DATE:	4/7/23	CO #:	Seven (07)
TO:	Trace Creek Construction, Inc. PO Box 539 Vanceburg, KY 41179	PROJECT:	Mercer County Board of Education 530 Perryville Street Harrodsburg, KY 40330 RTA 2203 BG 22-282
CONTRACT DATE:	July 20, 2022	CONTRACT FOR:	General Construction

1. PR#15 Baseball Dugout Piping per Field Order #12: \$7,247.94	
2. PR #17 Soccer drainage – new drain basin: \$4,424.00	
3. Electrical conduit to re-feed Musco lighting poles and the scoreboard; new quazite box: \$13,500.00	
TOTAL AMOUNT OF THIS CHANGE ORDER:	\$25,171.97

DATE:	March 1, 2023	PR #:	PR 015
TO:	Attn. Gus Bartley Trace Creek Construction	RE:	Mercer County Athletics Improvements Phase 1

DATE:	March 10, 2023	PR #:	PR 017
TO:	Attn. Eric Fryer Trace Creek Construction	RE:	Mercer County Athletics Improvements Phase 2

ENLARGED GRADING & DRAINAGE PLAN - FO-012
SCALE: 1"=10'

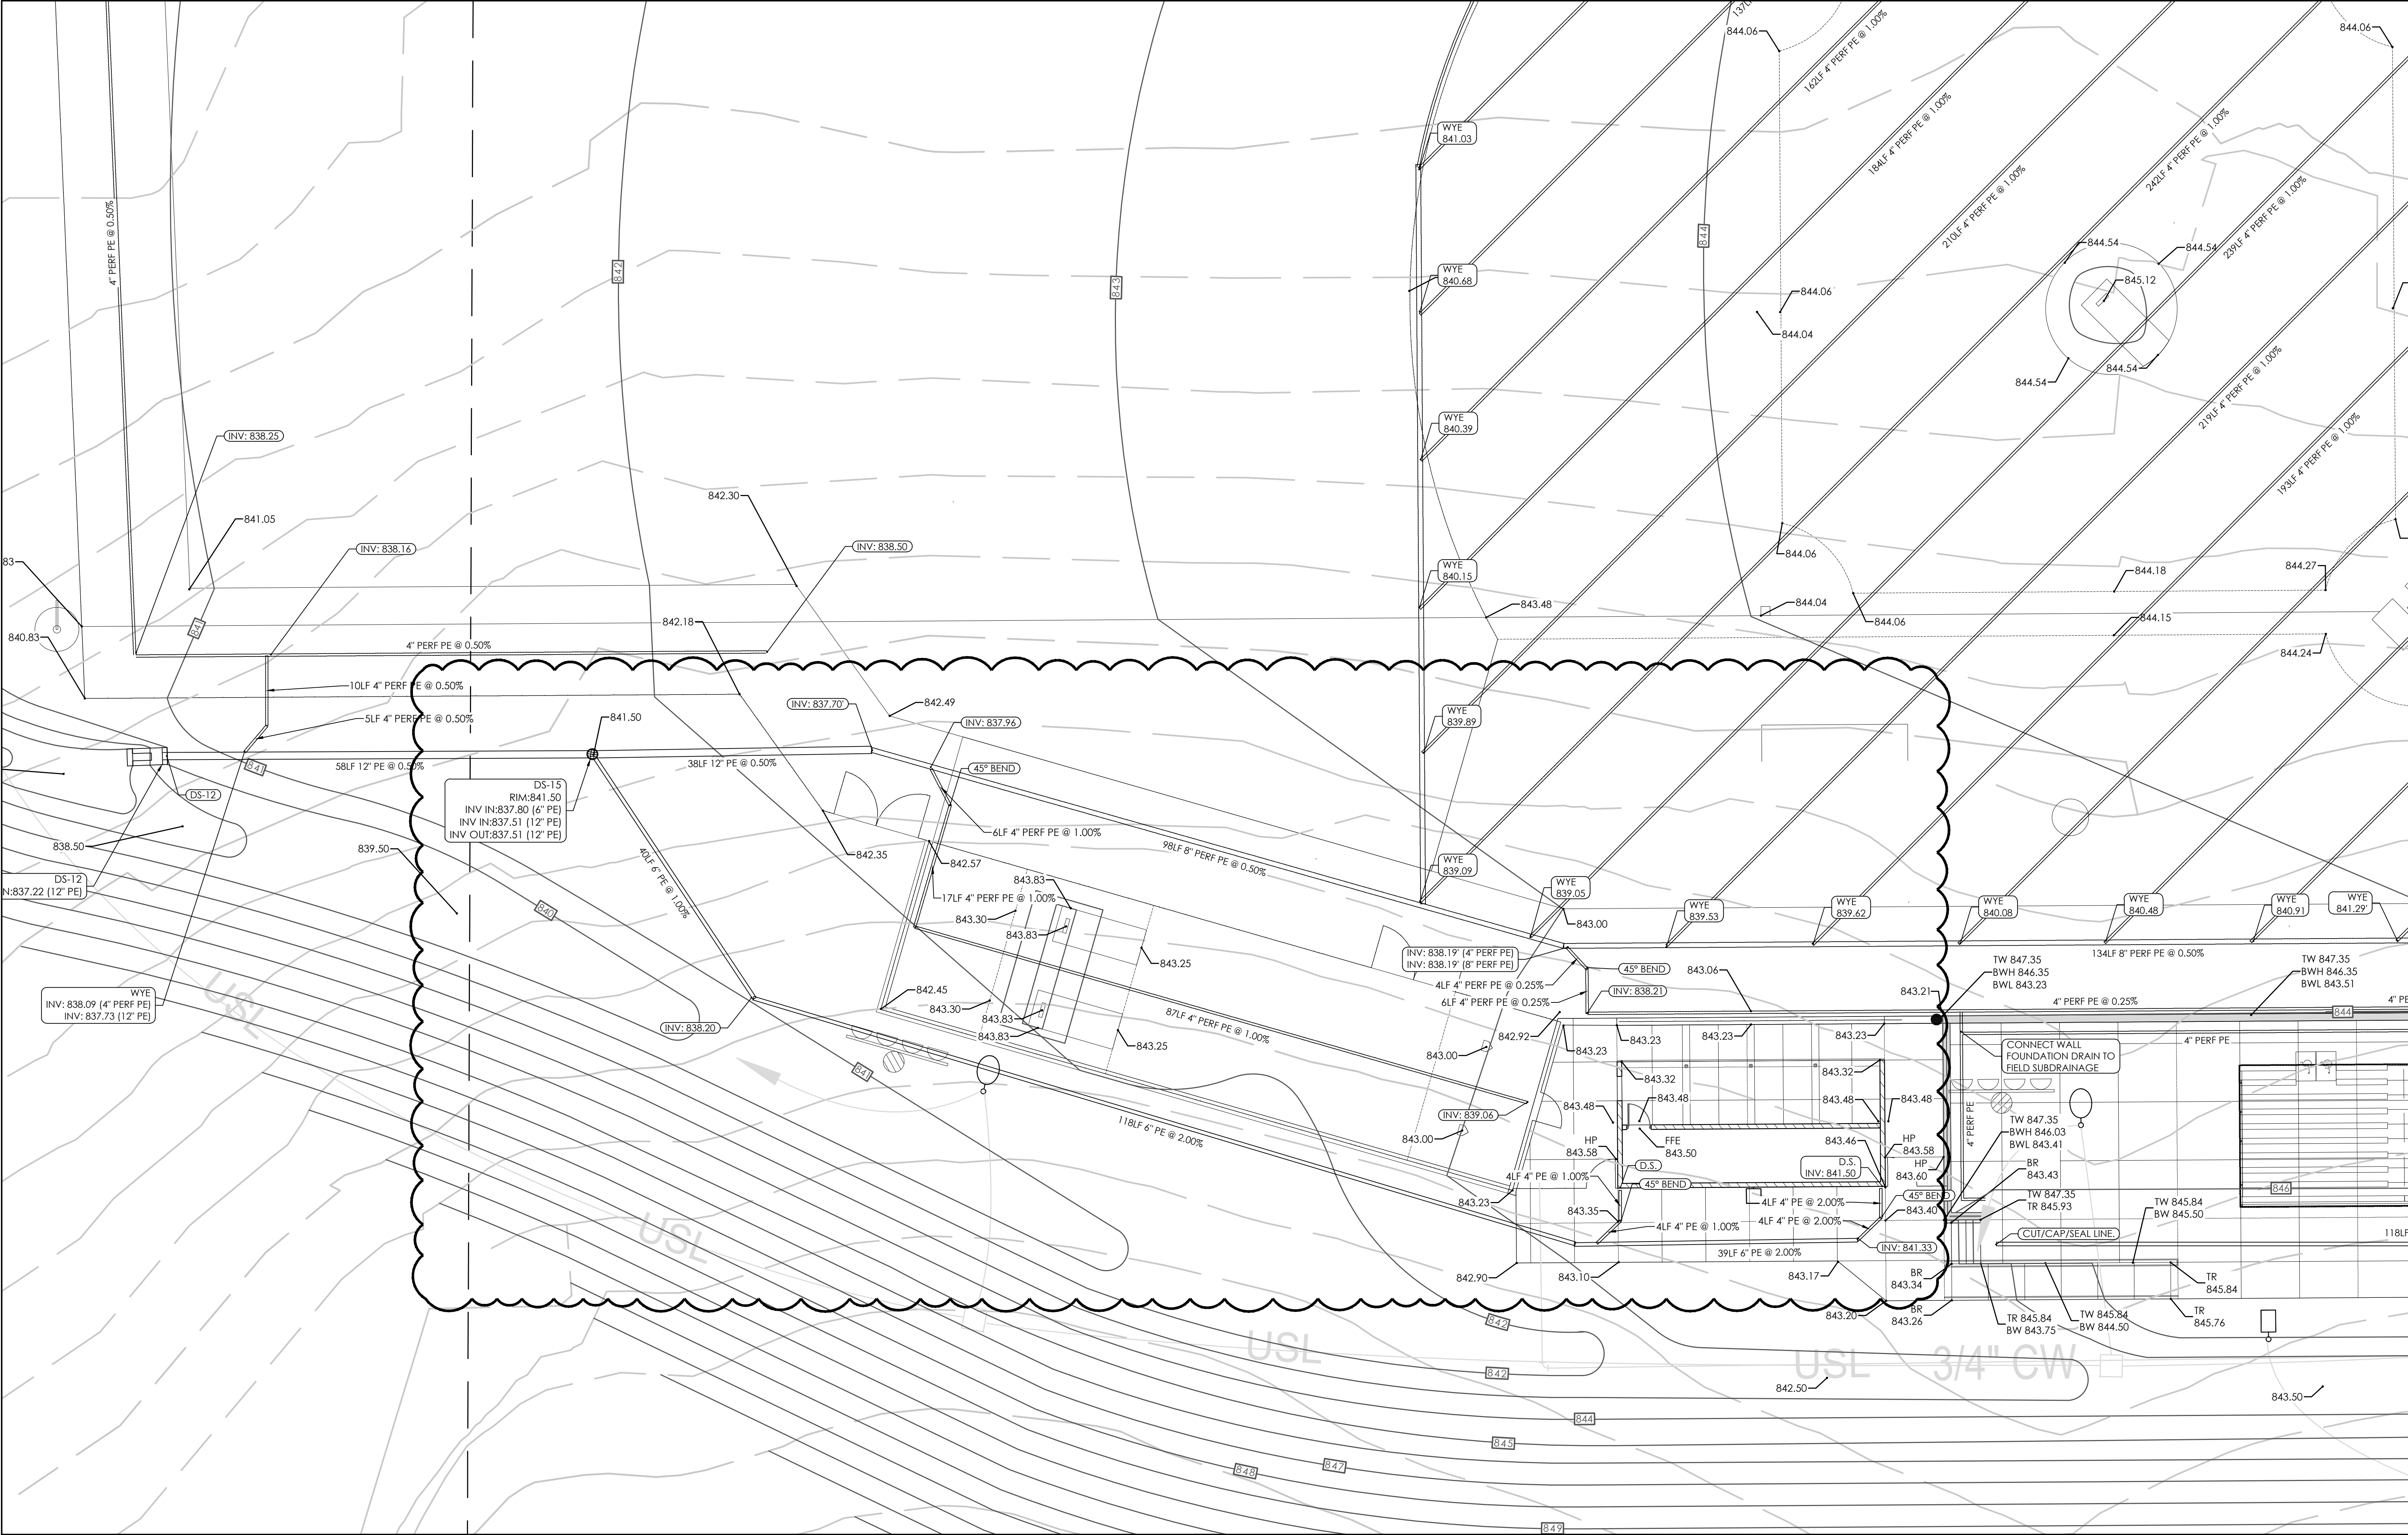
Please provide pricing for labor and materials for the changes to the baseball dugout piping as per the attached PDF

REVISE GRADING AND STORM PIPING AS SHOWN. PROVIDE AND INSTALL 18" DRAIN BASIN WITH STANDARD SLOTTED GRATE. SEE DETAIL E/1SD4.1.

2SD1.1

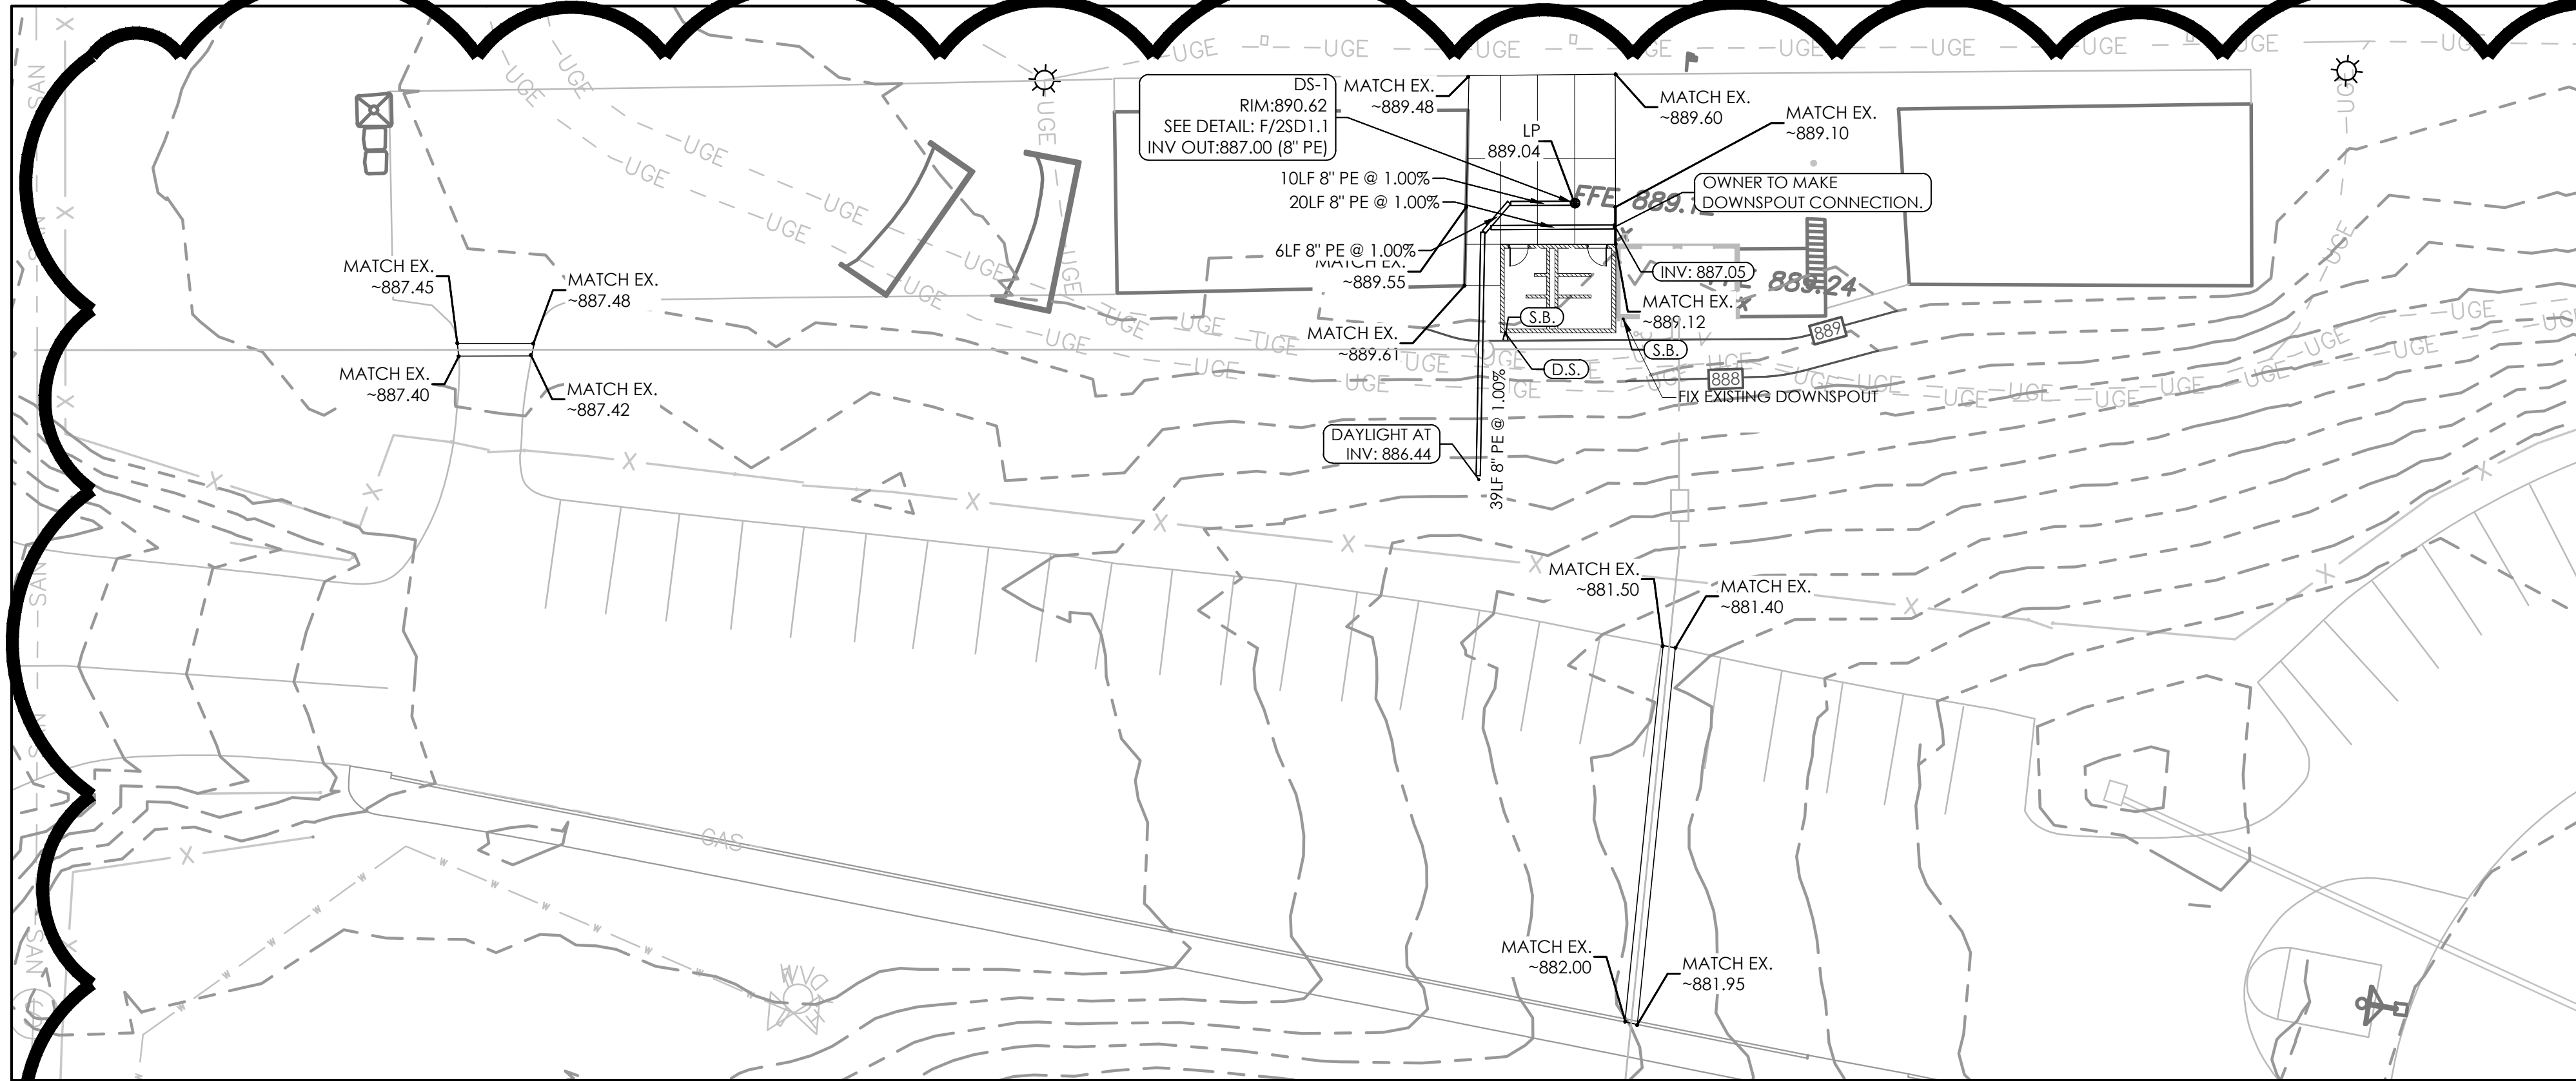
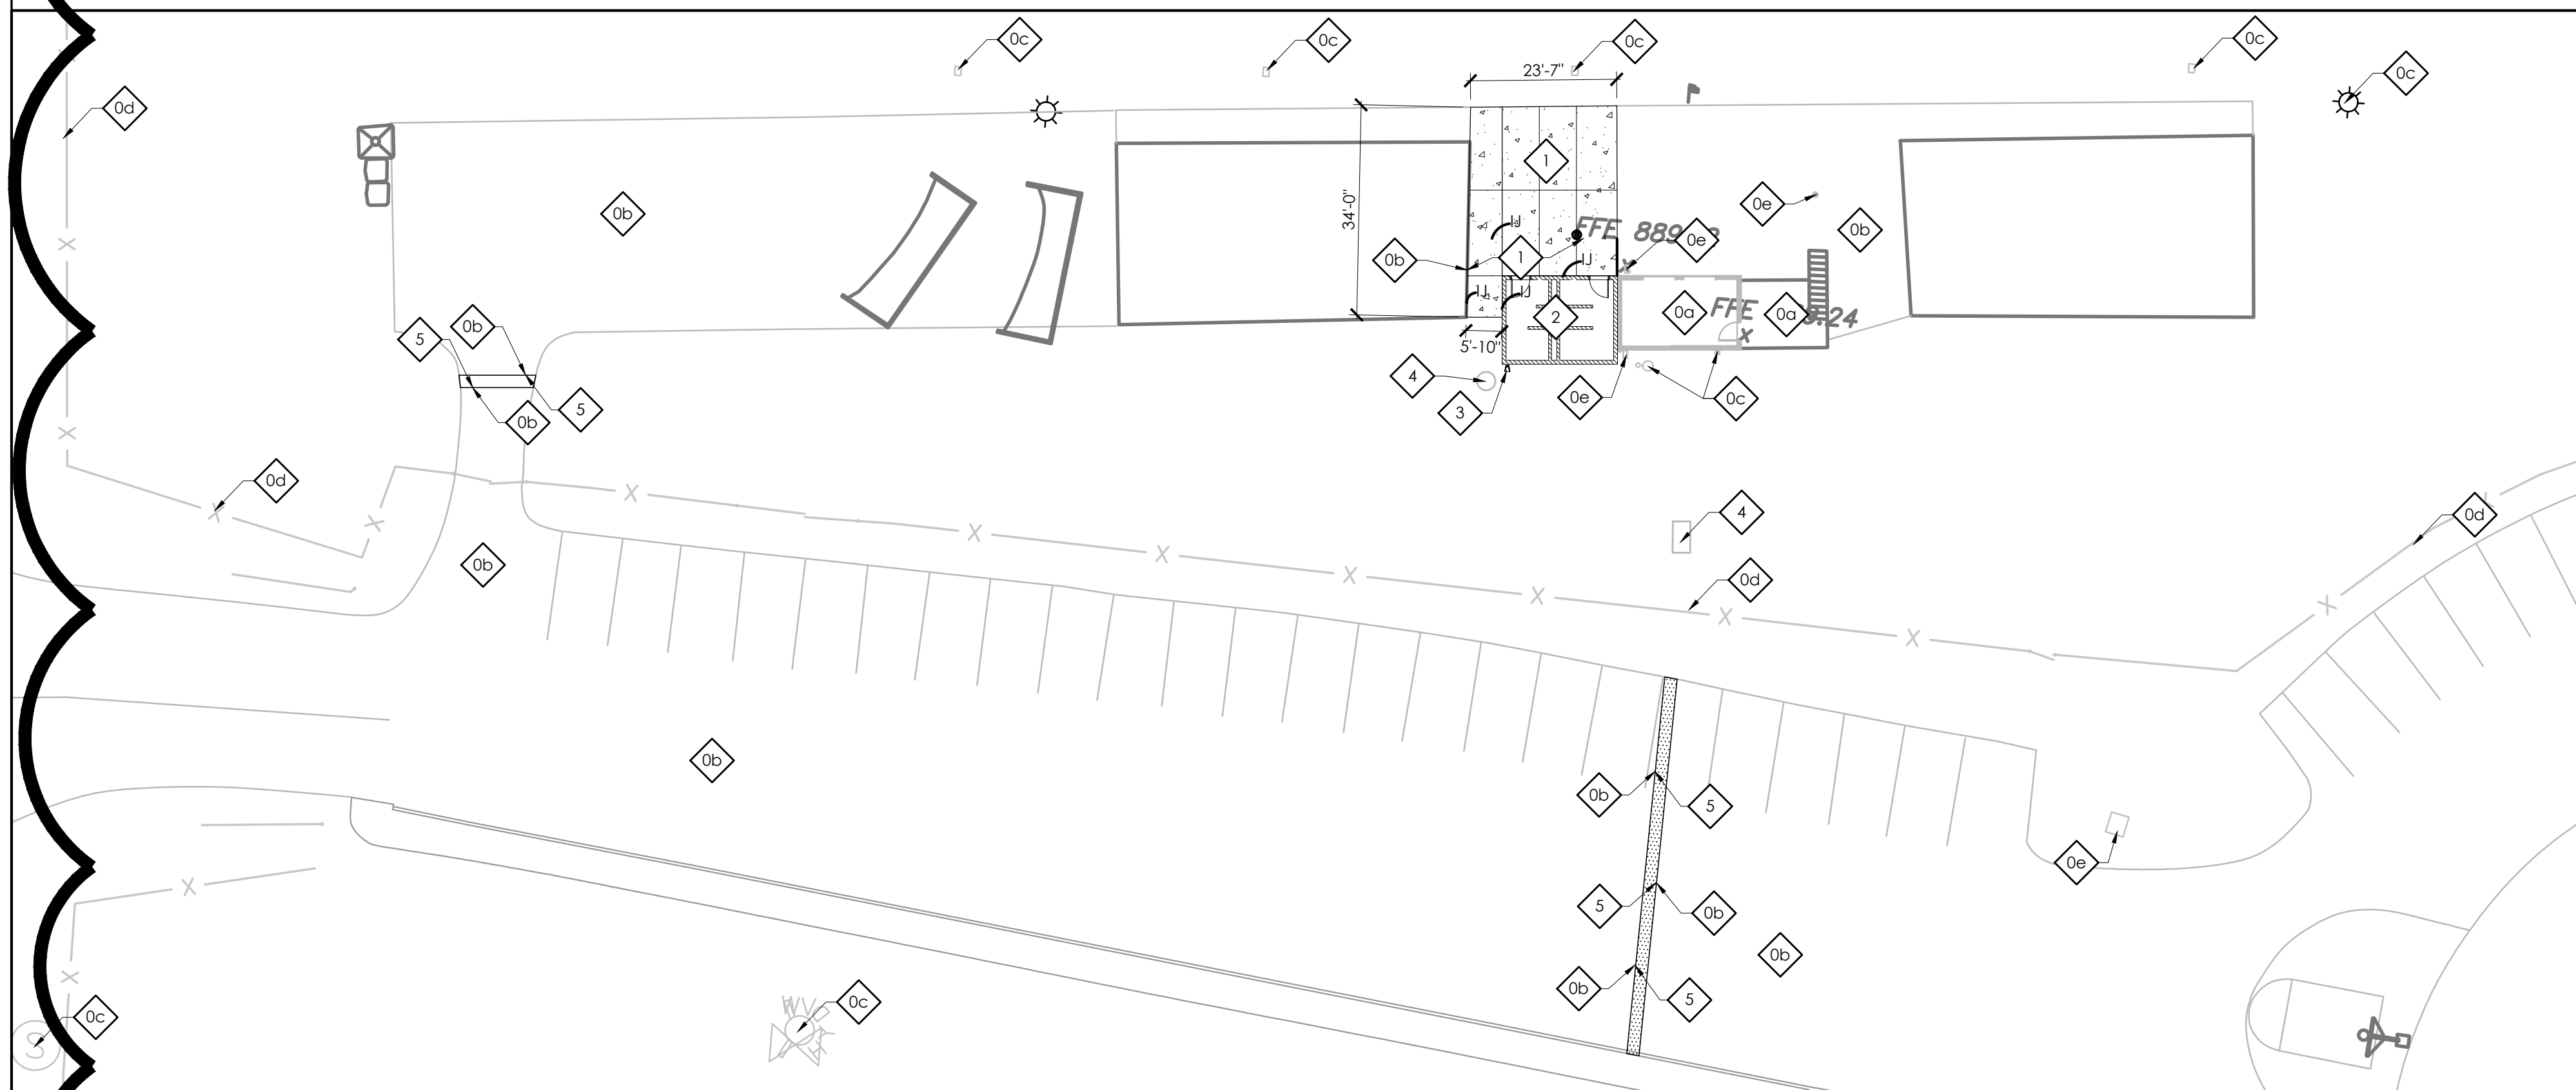
Contractor demolish and replace limits of concrete as shown on attached sketch. New 18" drain basin to be installed with piping as shown in attached sketch.
